Planning Committee: 1 June 2022.

Demolish House, Erect Seven Houses with Air Source Heat Pumps, Associated Parking and Landscaping and Create Access (Part Retrospective) at Oakdene, Cairston Road, Stromness.

Report by Corporate Director for Neighbourhood Services and Infrastructure.

Application Number:	21/346/PP.
Application Type:	Planning Permission.
Proposal:	Demolish a house, erect seven houses with air source heat pumps, associated parking and landscaping and create an access.
Applicant:	Orkney Builders Limited.
Agent:	Bracewell Stirling, c/o Lisa Balnave, 5 Ness Bank, Inverness, IV2 4SF.

Appendix 1: Site Plan.

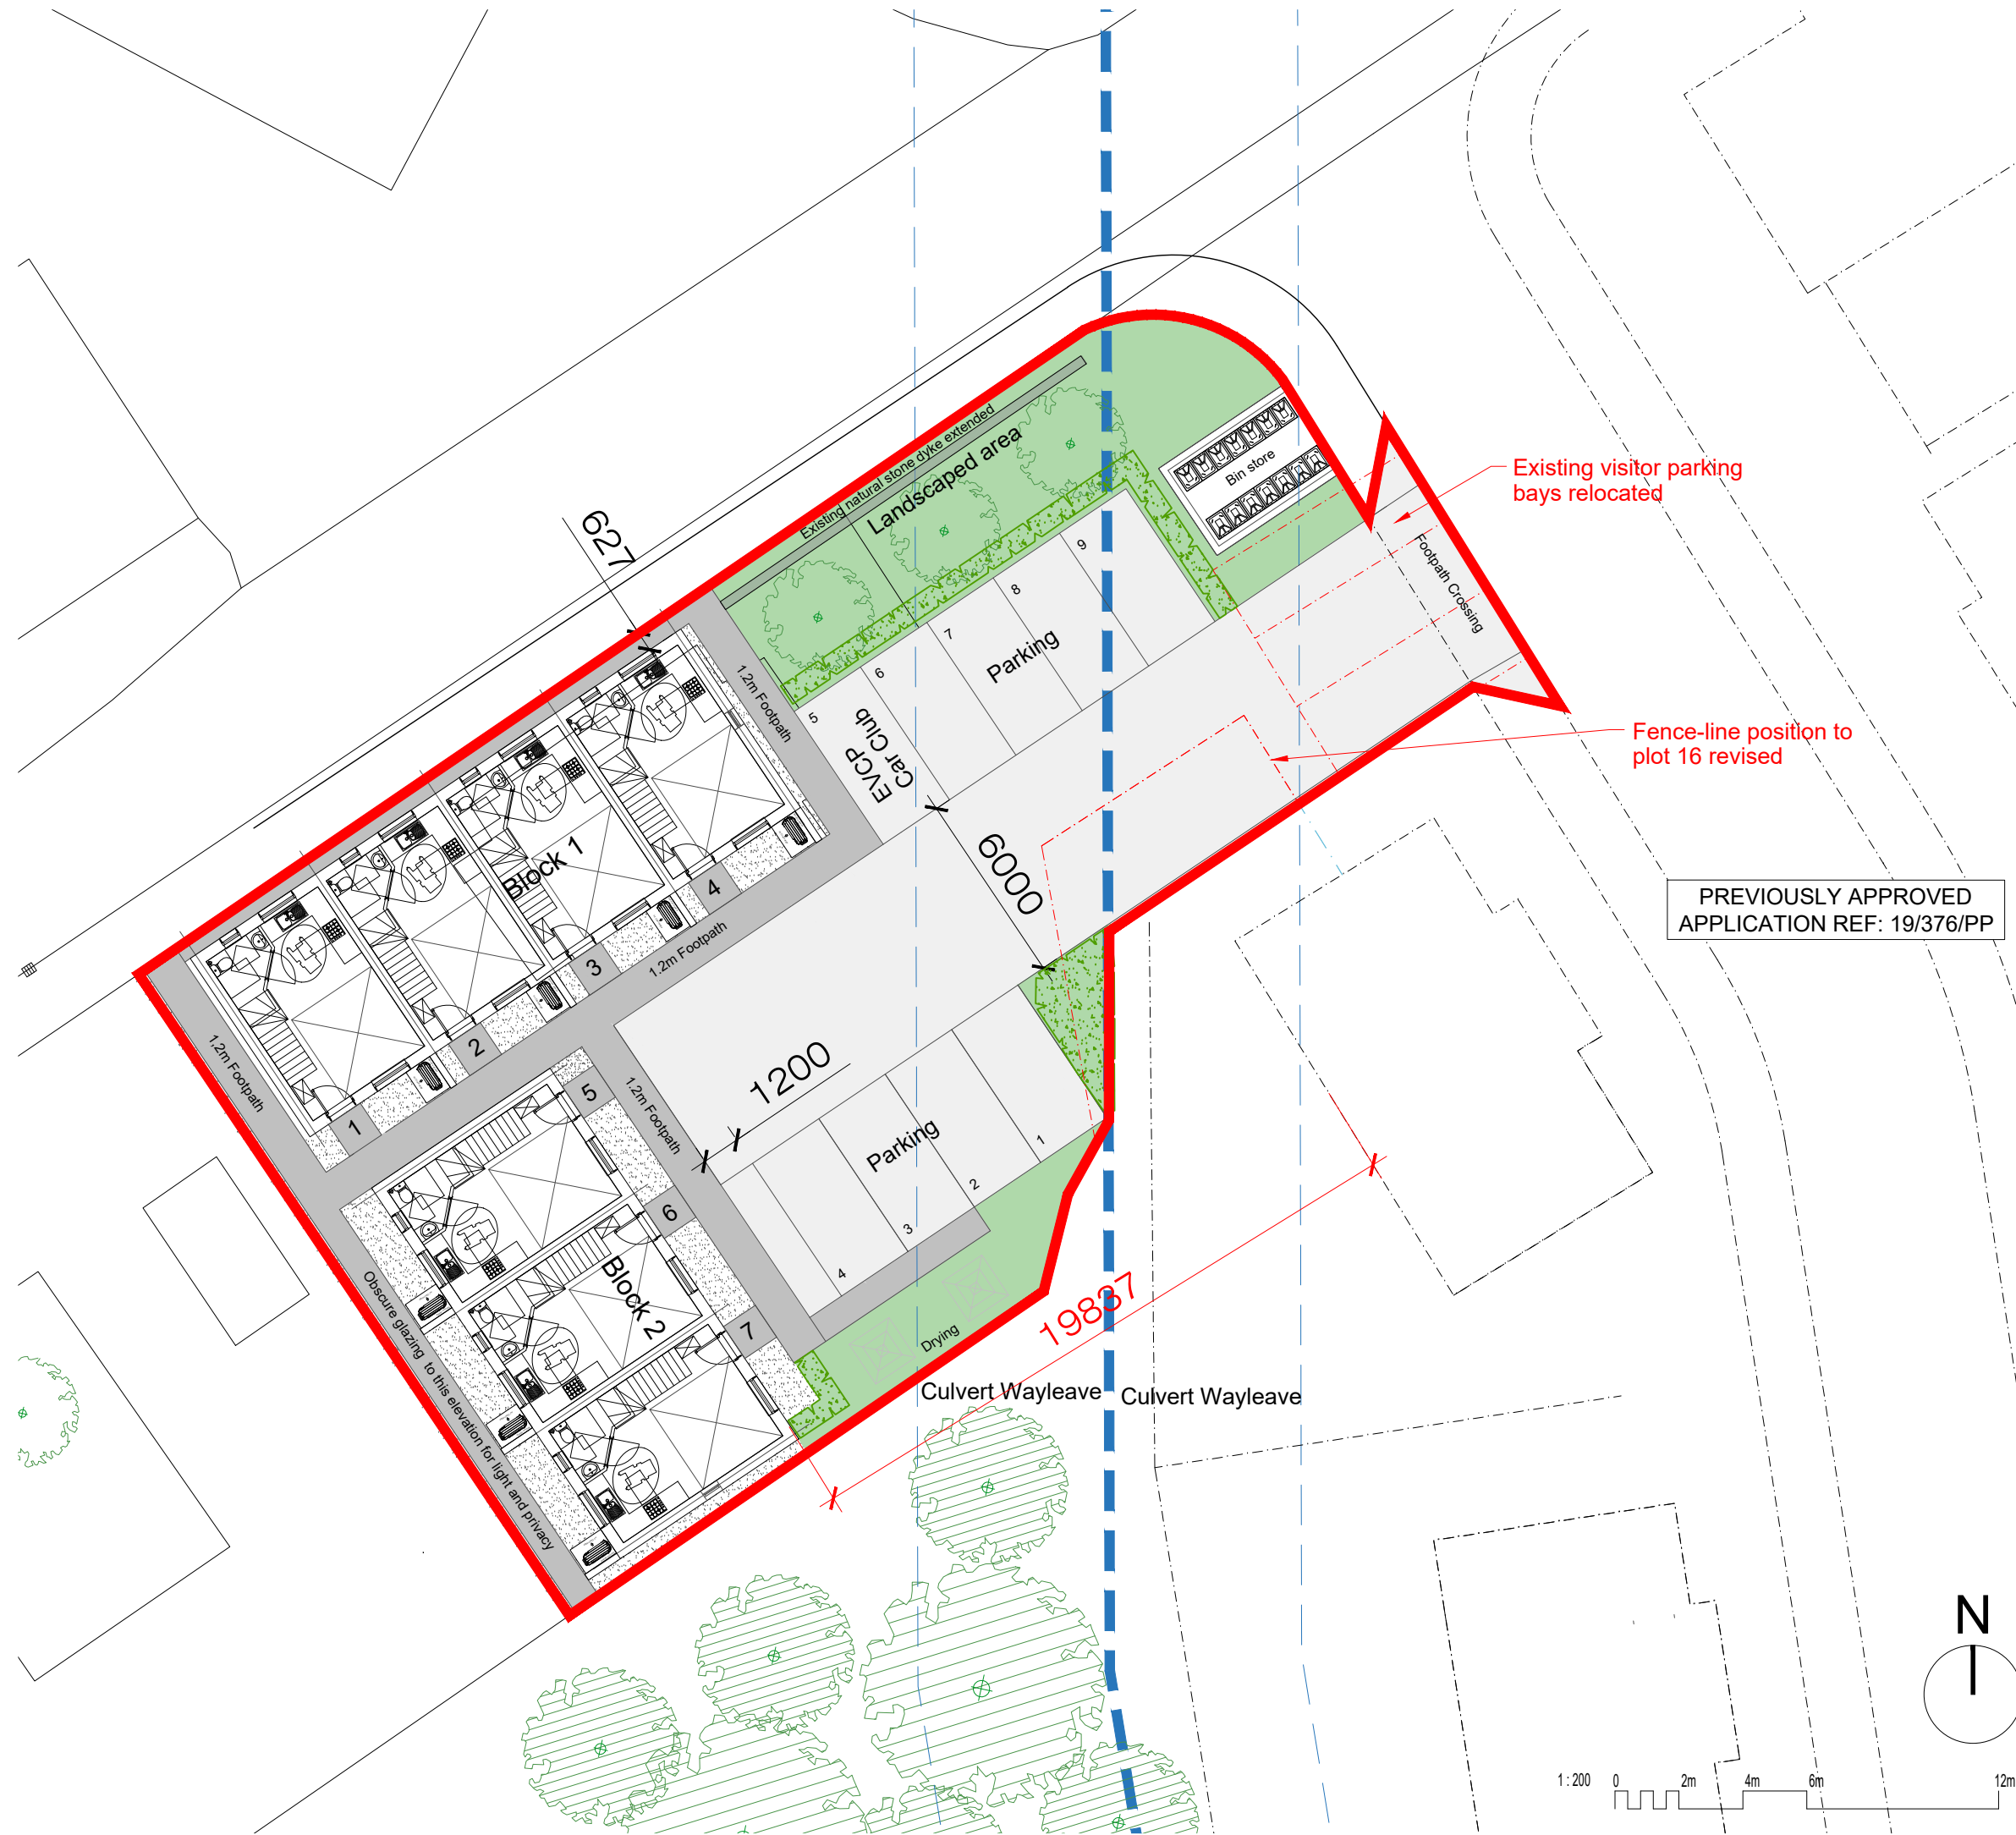
It is proposed to clear the site and erect seven houses in the form of two terraces. Block 1 would comprise a terrace of four houses, backing immediately onto Cairston Road in the north-west corner of the site. Block 2 would be a terrace of three houses, to the south of and perpendicular to Block 1, with both blocks fronting an internal parking area. The remainder of the site comprises the access road, parking, bin storage and a strip of planting adjacent to the access, as shown in the Site Plan attached as Appendix 1 to this report.

The development would take access from Yorston Drive, with a footpath crossing point. Following amendments, nine vehicle parking bays are proposed, including one electric vehicle parking bay. Roads Services has confirmed that the parking “should now be workable” and has no objection to parking provision.

The application site area includes the approved visitor parking spaces for Yorston Drive, leaving that existing development with no dedicated visitor parking. In that regard, Roads Services notes that the proposed development would result in “the

loss of visitor parking that was to be provided with adjacent development approved under planning ref 19/376/PP...it is not considered good practice to remove visitor parking in favour of an adjacent development and then to rely on on-street parking as the alternative solution". Therefore, it is appropriate to consider parking provision in relation to the development as proposed, but also in terms of its impact on existing development, and the loss of dedicated visitor parking which was considered a key requirement in a recently approved development. This in turn relates to the density of the proposed development, which is addressed later in this report.

As proposed, Block 1 is immediately on the north boundary of the site, with the terrace effectively forming the back edge of the public footway in that location. As such, pedestrians using the footway would pass immediately adjacent to the kitchen and (only) shower room window in the properties. A detail of UPVC panelling is proposed in the footway elevation to create the character of a door, but this does not replicate the character or function of a front door facing the street. The combination of the alignment of the block immediately against the footway, the resultant lack of setback and garden ground between the footway and the building, lack of active frontage by being a shower room and kitchen window facing the street, exacerbated by the mass of the building, being a block of four houses, combine to the effect that the building would be out of character with the remainder of the street.

Advice provided at the pre-application stage was that an increase in the number of units could be accepted, noting that the current application is to replace one house with seven houses. The option presented was for a terrace following the design approach of Block 1 but set back into the site to match the character of neighbouring houses and the remainder of the street, with an active frontage; although it would be an additional number of units, given that the individual units are small, the terrace would be similar in scale to some other individual houses. However, the effect of proposing the terrace in the location submitted, to fit a second terrace of three houses to the south, makes the layout and density unacceptable.

On balance, design concerns are of such weight that the application cannot be supported. The density of development, and critically the proposed siting of a block of four houses immediately against the footway, with bathroom and kitchen windows and no pedestrian access from the houses, would have a negative impact on the established character of the area. The development is considered contrary to Policies 1 and 2 of the Orkney Local Development Plan 2017. Accordingly, the application is **recommended for refusal**.

01. By virtue of the location of the proposed Block 1 within the application site, the number of houses proposed and the proposed site layout, the development is not considered to be 'sited and designed taking into consideration the location and wider townscape character' and it is considered that the 'proposed density of development is not appropriate to the location'. The development is therefore contrary to Policy 1: Criteria for All Development of the Orkney Local Development Plan 2017.

02. The proposed design would not 'reinforce the distinctive identity of Orkney's built environment', is not 'sympathetic to the character of the local area' and the development would not have 'a positive effect on the appearance and amenity of the area'. The development is therefore contrary to Policy 2: Design of the Orkney Local Development Plan 2017.
